South Texas Project  
Units 1 and 2  
Docket Nos. STN 50-498, STN 50-499  
Response to Request for Additional Information for the  
Review of the South Texas Project, Units 1 and 2,  
License Renewal Application – Set 31 (TAC Nos. ME4936 and ME4937)

**STPNOC Response to RAI**

Figure 1 - Updated Figure 4-1 from AES-C-1964-5

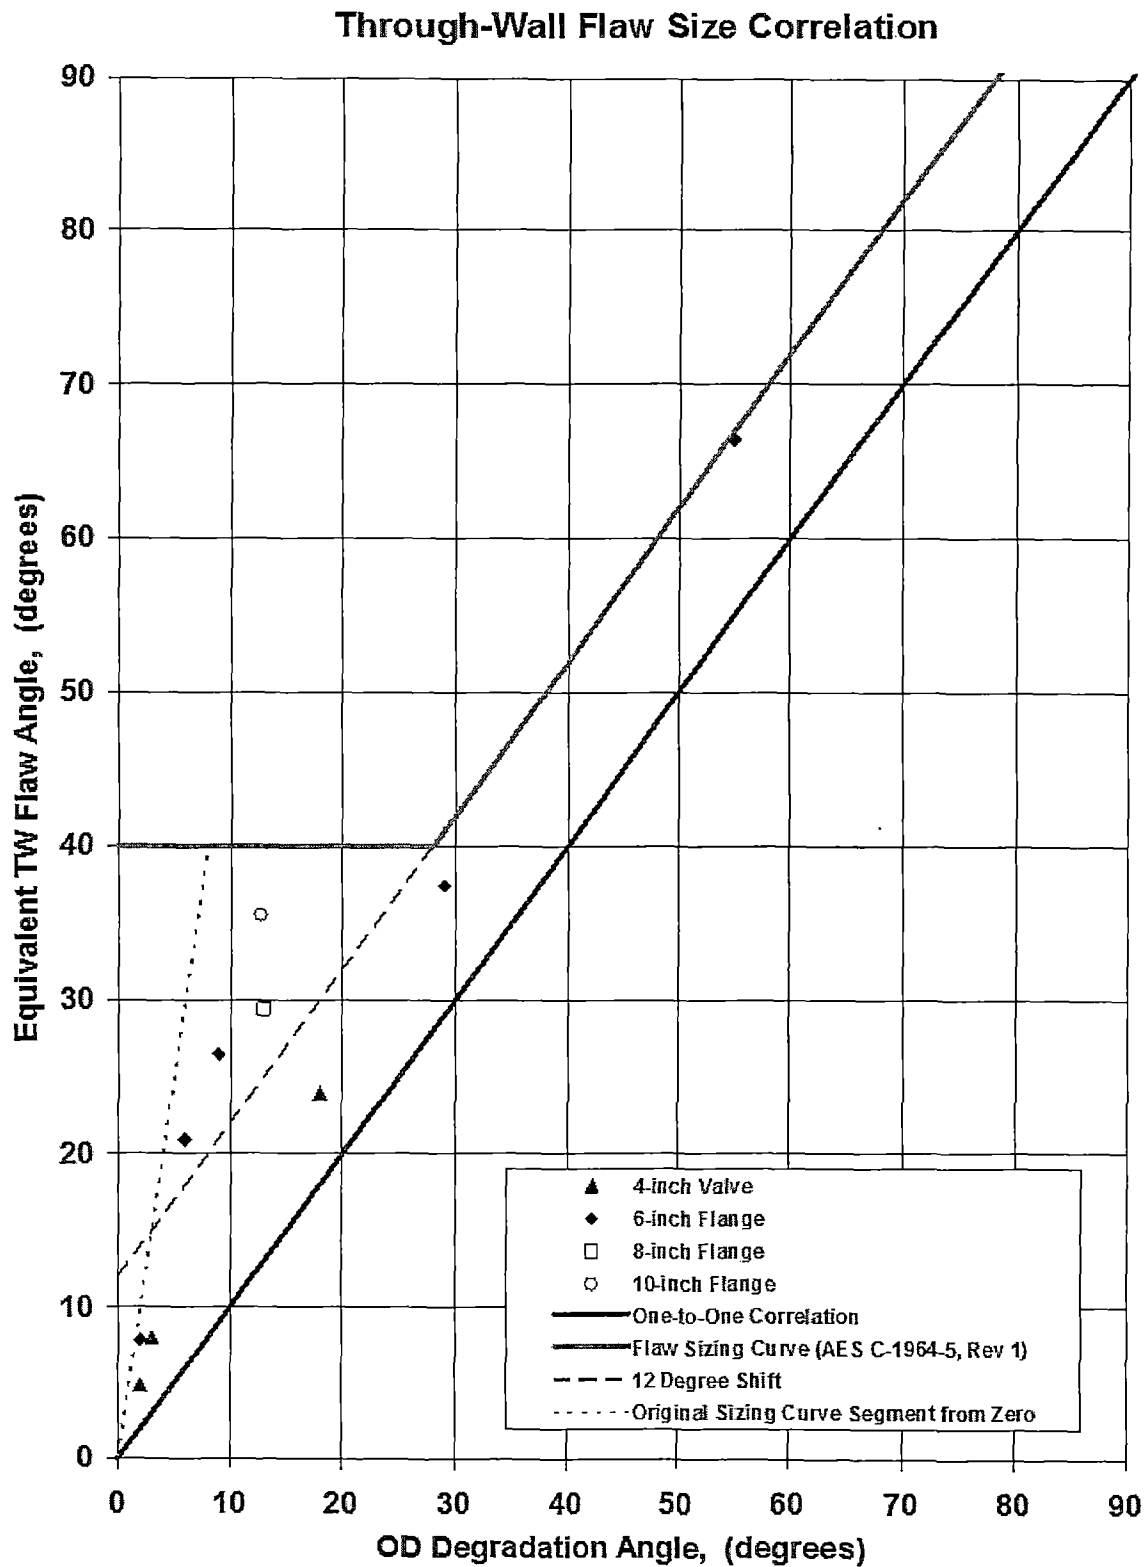
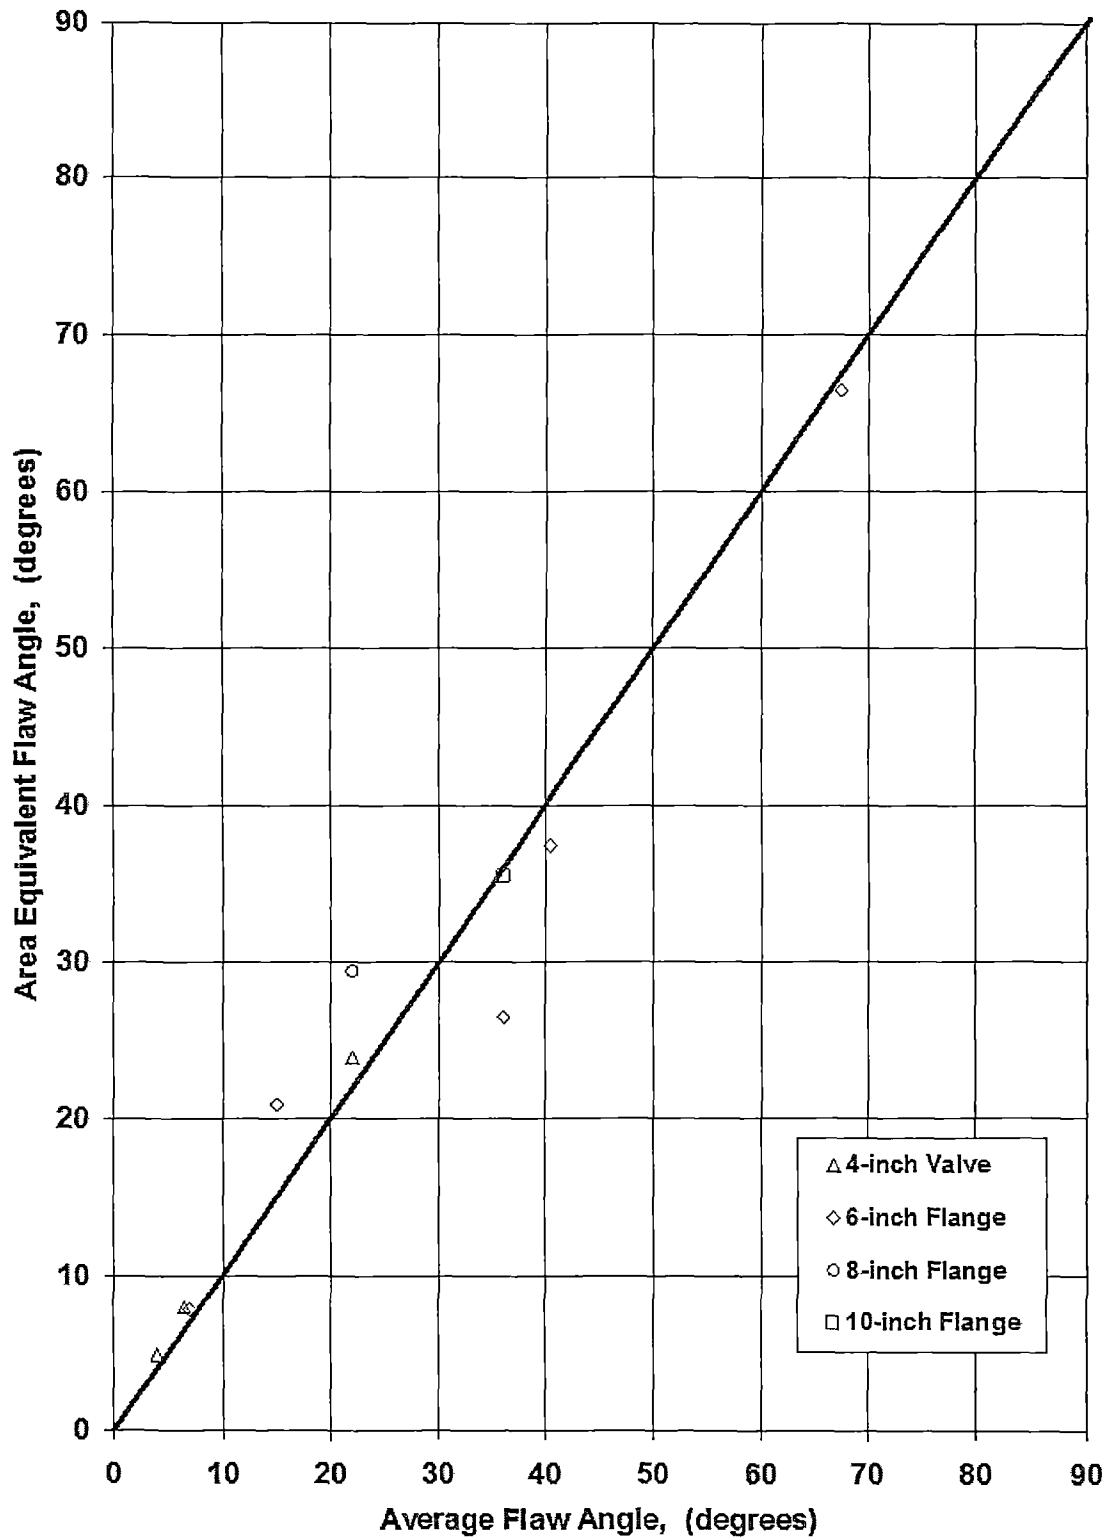
State and justify the basis for use of an average through-wall dealloying angle as the output of the flaw-sizing correlation in Figure 4-1 of AES-C-1964-5.

The flaw sizing correlation of Figure 4-1 is now based on this equivalent area method. This definition will result in TW flaw sizes comparable or more conservative than GL 90-05 since  $t_{\min}$  for the ECW piping is relatively small. Using the dealloying angle measured at  $t_{\min}$  in accordance with GL 90-05 would bias the assumed TW flaw length towards the length measured on the outside surface.

Figure 1 in RAI B.2.1.37-6-3 response below show the new Figure 4-1. Both the "average TW flaw" and "equivalent area" TW flaw are very similar. Figure 2 below compares the two definitions. Past evaluations using Figure 4-1 remain valid and conservative.
